WCAP 16168-NP-A, Rev 2

**Transmittal of NRC Approved Topical Report WCAP-16168-NP-A,  
Rev. 2 "Risk-Informed Extension of Reactor Vessel In-Service  
Inspection Interval" (TAC NO. MC9768) (MUHP 5097/5098/5099  
Task 2008/2059, PA MSC-0120)**

# **Risk-Informed Extension of the Reactor Vessel In-Service Inspection Interval**

**WCAP-16168-NP-A**  
**Revision 2**

Figure 3-1 Comparison to Acceptance Criteria – Minimum Margins Code Allowable

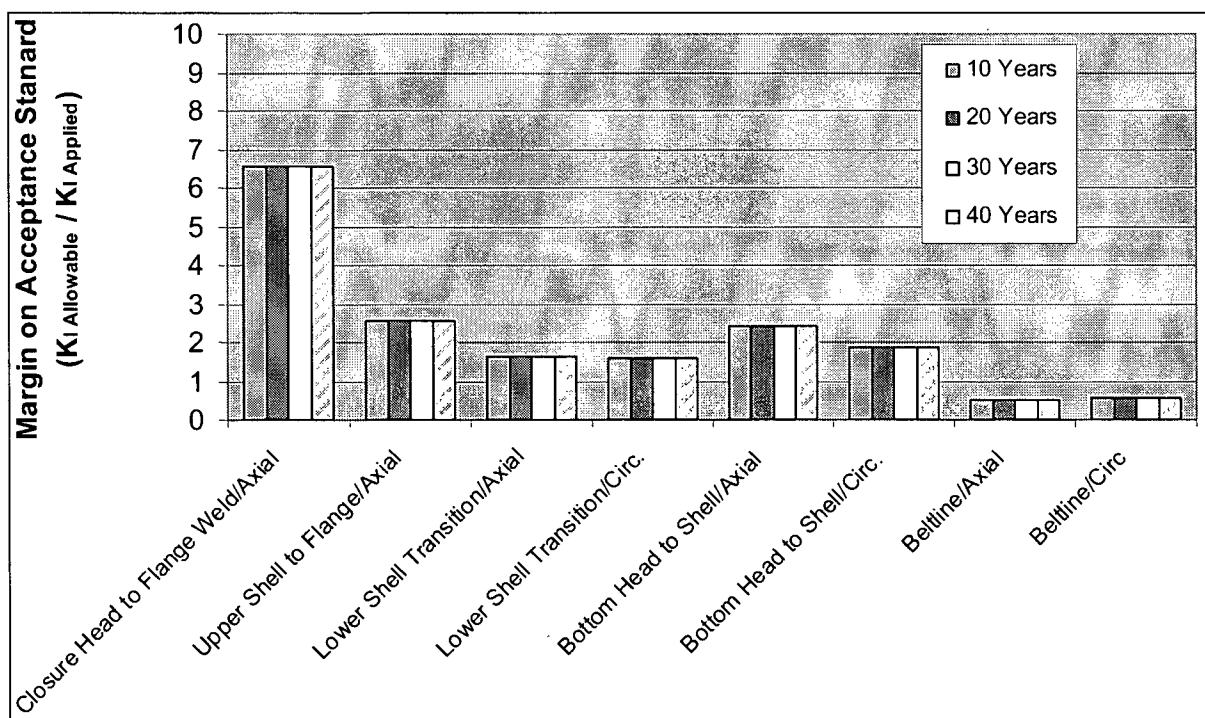
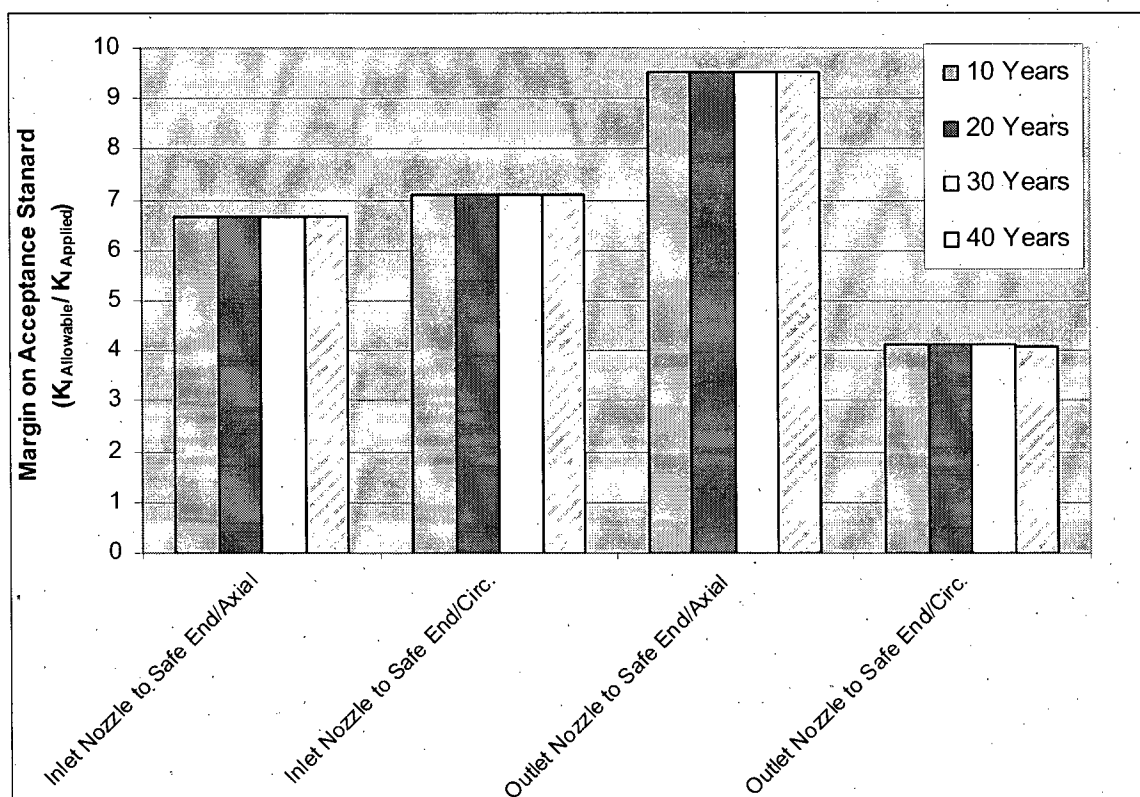
the TR indicated that the beltline welds have the lowest ratio of ASME Code allowable stress intensity values ( $K_{I \text{ allowable}}/K_{I \text{ applied}}$ ). These figures do not include the full penetration nozzle-to-vessel welds. The NRC staff requested that the PWROG provide the ratio of ASME Code allowable stress intensity value for full penetration nozzle-to-vessel welds to demonstrate that the beltline welds were the limiting locations. In the response to RAI 5 from Reference 3, the PWROG provided the requested information. The PWROG analyses indicated that the beltline is more limiting than the full penetration nozzle-to-vessel welds.

5. WCAP-16168-NP, Revision 1 was written to justify increasing the inservice inspection interval from 10 to 20 years for ASME Code, Section XI, Category B-D welds, "Full Penetration Welded Nozzles in Vessels." Figures 3-1 and 3-2 indicate that the beltline welds have the lowest ratio of code allowable stress intensity values ( $K_{I, \text{allowable}}/K_{I, \text{applied}}$ ). These figures do not include the full penetration nozzle to vessel welds. The staff requests that the WOG provide the ratio of code allowable stress intensity value for full penetration nozzle-to-vessel welds to demonstrate that the beltline welds are the limiting locations.

Figure A-4300-2, Reference Fatigue Crack Growth Curves for Carbon and Low Alloy Ferritic Steels Exposed to Water Environments  
(From Appendix A of Section XI of the ASME BPV Code)

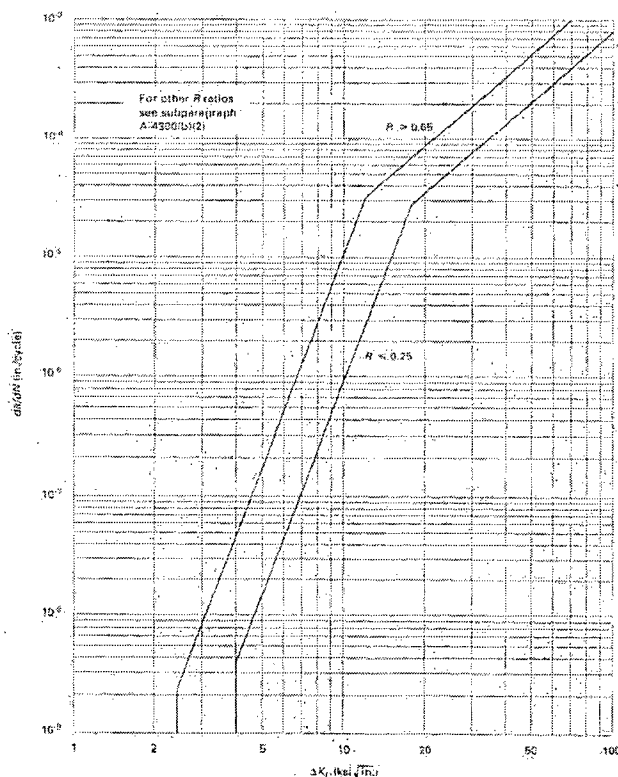
Vessel Code." Figure A-4300-2, "Reference Fatigue Crack Growth Curves for Carbon and Low Alloy Ferritic Steels Exposed to Water Environments," from Appendix A to Section XI in the current edition of the ASME Code, provides a graphical representation of these equations. It should be noted that the fatigue crack growth curves in Appendix A of Section XI of the ASME Code have not changed since they were originally included in the 1978 Edition of Section XI. Since the crack growth rate code used in the PWROG analysis was taken directly from a code that was previously reviewed and approved by the NRC staff in Reference 13 and is based on the ASME Code crack growth rate curves, the crack growth rate code used in the PWROG analysis is acceptable.

**Response:** The fatigue crack growth rate equations for ferritic materials, such as the vessel wall base metal, are taken from Section 4.2.2 of the *Theoretical and Users Manual for pc-PRAISE* (NUREG/CR-5864, July 1992). As noted in this report, these "equations provide a probabilistic representation of the fatigue growth relationship for ferritic materials in water contained in Appendix A of Section XI of the ASME Boiler and Pressure Vessel Code." Figure A-4300-2, Reference Fatigue Crack Growth Curves for Carbon and Low Alloy Ferritic Steels Exposed to Water Environments, from Appendix A to Section XI in the current edition of the ASME Boiler and Pressure Vessel Code, is also provided below for a graphical representation of these equations. It should be noted that the fatigue crack growth curves in Appendix A of Section XI of the ASME Boiler and Pressure Vessel Code have not changed since they were originally included in the 1978 Edition of Section XI. Furthermore, there are presently no known plans to revise the curves in the future.

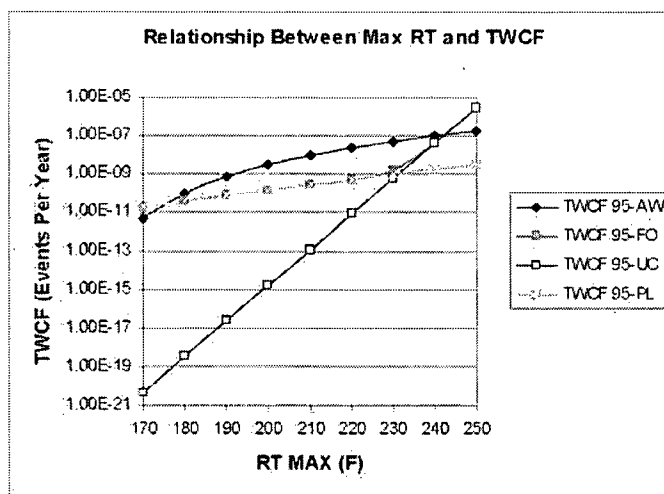
2. In Attachment 1 to the June 8, 2006 letter from the WOG, the WOG indicated that under-clad cracks in forgings are so shallow that chance for them initiating during a severe pressurized thermal shock (PTS) transient would be fairly small. Analyses (NUREG-1874, "Recommended Screening Limits for Pressurized Thermal Shock (PTS)") performed by the staff indicates that for severe PTS transients the through wall crack frequency (TWCF) for forgings with under-clad cracks are greater than those for axial welds with equivalent material reference temperature. How does the staff analysis impact the WOG analyses and the TWCF pilot-plant screening criteria in Appendix A of WCAP-16168-NP, Revision 1?

**Response:** The statement in the Staff's question that "the through wall crack frequency (TWCF) for forgings with under-clad cracks are greater than those for axial welds with equivalent material reference temperature" is only valid for reference temperatures greater than 240°F. Below this temperature, the TWCF of forgings is equivalent to that of plates. This is confirmed by plotting the TWCF correlations in NUREG-1874 for plates (PL), axial welds (AW), forgings (FO), and

under-clad cracking (UC) on the same graph as shown below.
